CHEVY COLORADO/GMC CANYON SIDE RAIL INSTALLATION

Call Toll Free: 1-877-TRUXEDO (1-877-878-9336) Fax: (605) 664-9304 Visit Us Online: <http://www.truxedo.com> P/N 1115963

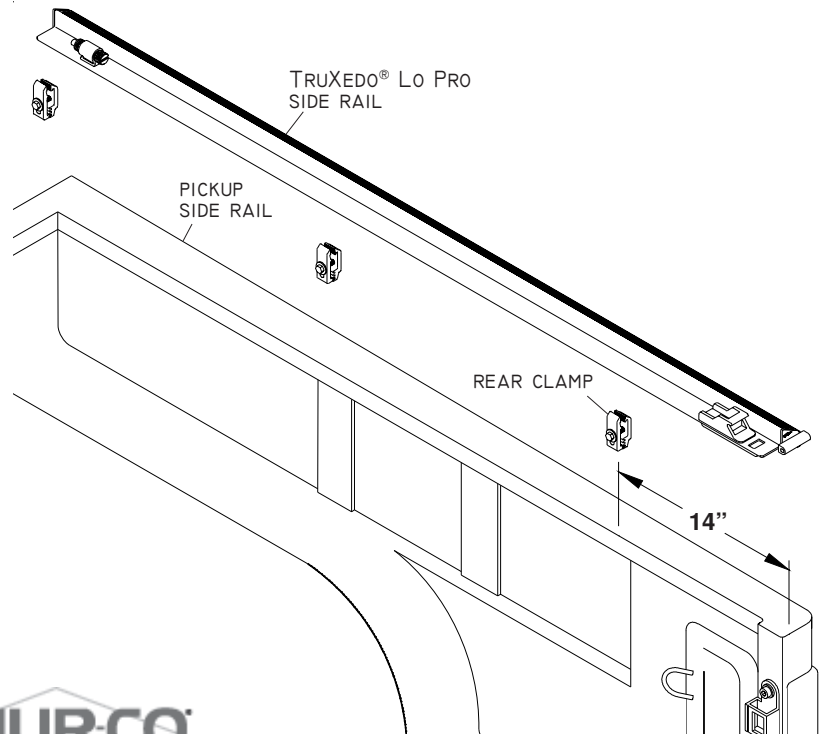
It is not possible to fasten the rear clamps 8" from the tailgate, as shown in the Owner's Manual, because of the contour of the pickup bed rails.

Follow the Owner's Manual instructions to install side rails on your Chevy Colorado or GMC Canyon pickup with this exception: Install the rear clamps 14" in front of the tailgate.

CHEVY COLORADO/GMC CANYON SIDE RAIL INSTALLATION

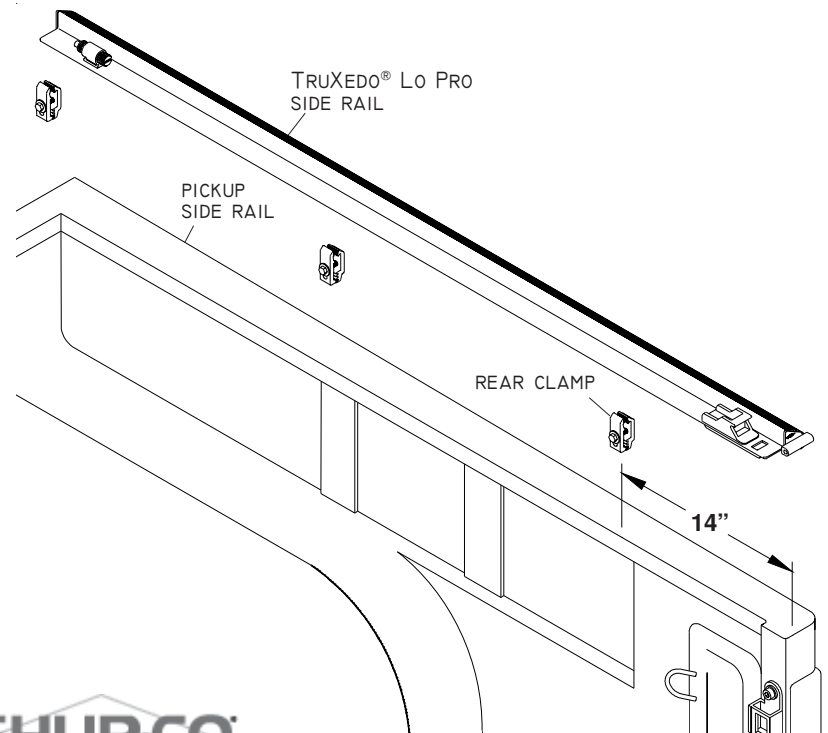
It is not possible to fasten the rear clamps 8" from the tailgate, as shown in the Owner's Manual, because of the contour of the pickup bed rails.

Follow the Owner's Manual instructions to install side rails on your Chevy Colorado or GMC Canyon pickup with this exception: Install the rear clamps 14" in front of the tailgate.
